Planning Commission - Regular Meeting City and Borough of Juneau Ben Haight, Chair

August 8, 2017
Assembly Chambers
7:00 PM

- A. AME2016 0019: Deletion of CBJ code 49.70.310 (a) (2 and 3), Eagle Nest Buffers.
B. CSP2017 0013: A consistency review for reconstruction of Egan Drive between Tenth St. & Main St.

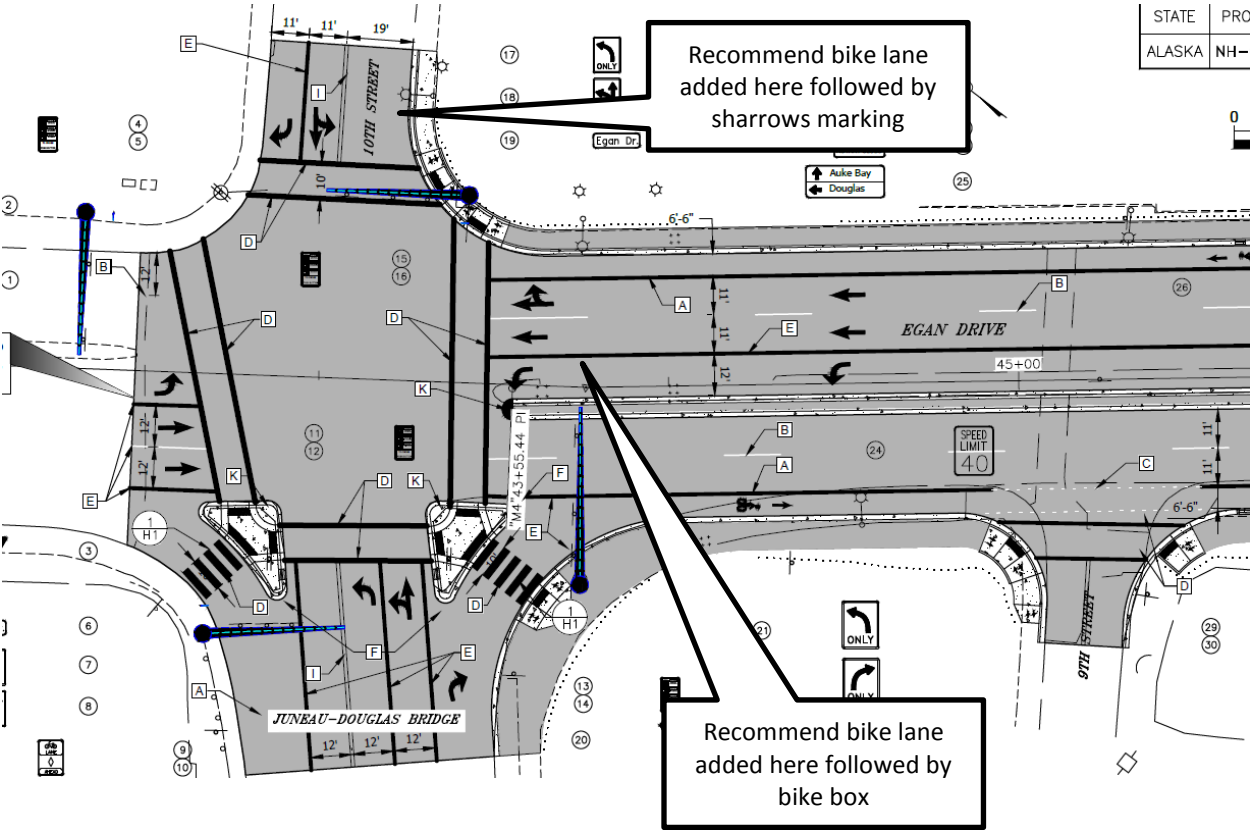
The plans do not show how bicyclists will be guided to navigate through the 10th and Egan intersection. *It is recommended as a condition of approval that a cycle only turn lane for bicyclists turning from Egan Drive onto the bridge be provided in accordance with MUTCD standards if ROW width allows.*

Proposed design of new crosswalk across Egan Drive at Willoughby Avenue

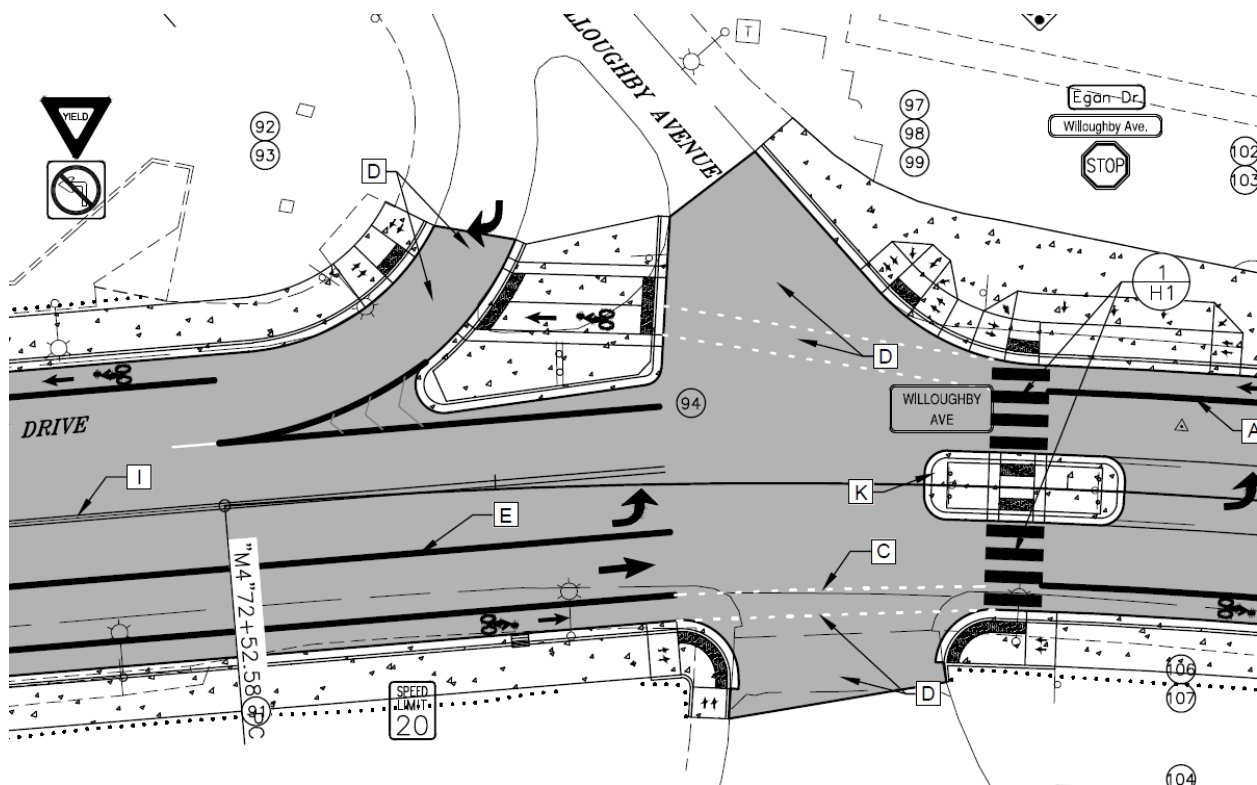
The **Willoughby Avenue crossing** will be in a 20mph zone and only over a single lane before pedestrians reach the refuge. A pedestrian activated beacon is not necessary and is not proposed by DOT&PF. The striping plan does not show crosswalk markings across Willoughby Avenue which is the obvious continued path of travel for users of the new crossing. It is recommended as a condition of approval that DOT&PF provide crosswalk markings using continental/ladder style striping across Willoughby Avenue.

DOT&PF are concerned about having to hand clear snow in the pedestrian refuges at both new crossings due to a raised median being either side. The Design Study Report suggests that the design may be modified following later in the design process to reduce or eliminate the need to hand clear snow. It is recommended that DOT&PF should retain the raised medians as shown in the plans at Glacier Avenue and Willoughby intersections to replace with them with striped refuges. While not a required design standard of the JNMTP, raised medians are noted as providing safer pedestrian crosswalks. As discussed below the medians provides an opportunity to add attractive vegetative cover at an entrance to downtown – this also acts as traffic calming by reinforcing to drivers that they should travel at a lower speed (to be posted as 20 mph in this area Willoughby Avenue intersection).

**CBJ proposal for Egan Drive and Seward Street intersection based on Front and Franklin
 Reconstruction conceptual design including removal of left turn and repositioning of existing crossing**

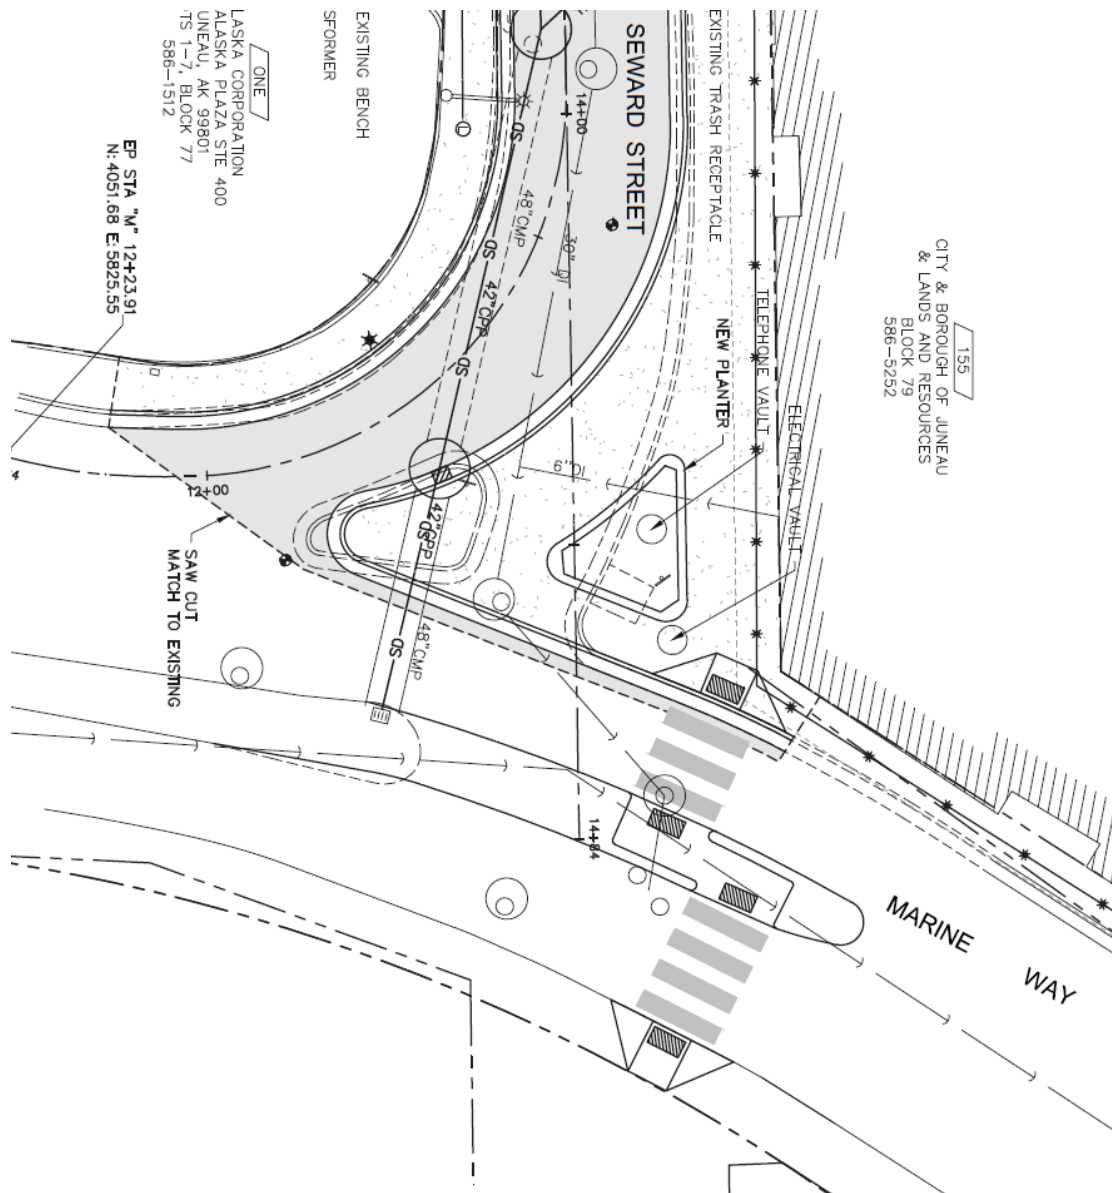
Removal of some existing landscaped strips on seaward side of Egan Drive and parts of central median – The existing central median will be widened from 13 ft to 14ft from Gold Creek to the Whittier Street. DOT&PF state that this is to meet the AASHTO highway design requirements

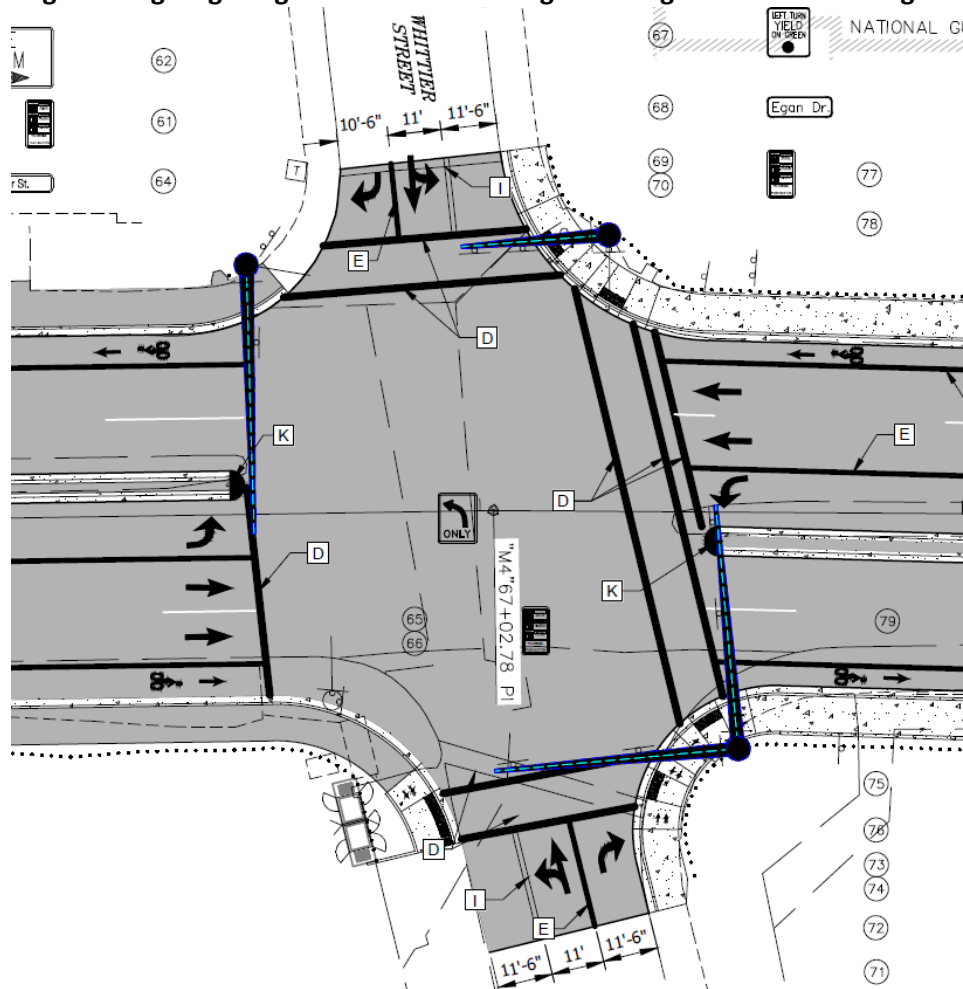
The raised median islands at the intersection of Willoughby Avenue are shown as being paved. The Willoughby Plan shows the existing island as being vegetated although the Waterfront Plan does not address landscaping at this intersection. In the interests of traffic calming and helping to identify the start of the existing downtown area, the raised islands around this intersection would benefit from further landscaping with vegetation or creative hardscaping. *It is recommended as a condition of approval that DOT&PF work with CBJ to develop and implement a plan for more attractive treatment of the raised median islands at the Willoughby intersection including at the new crossing.*
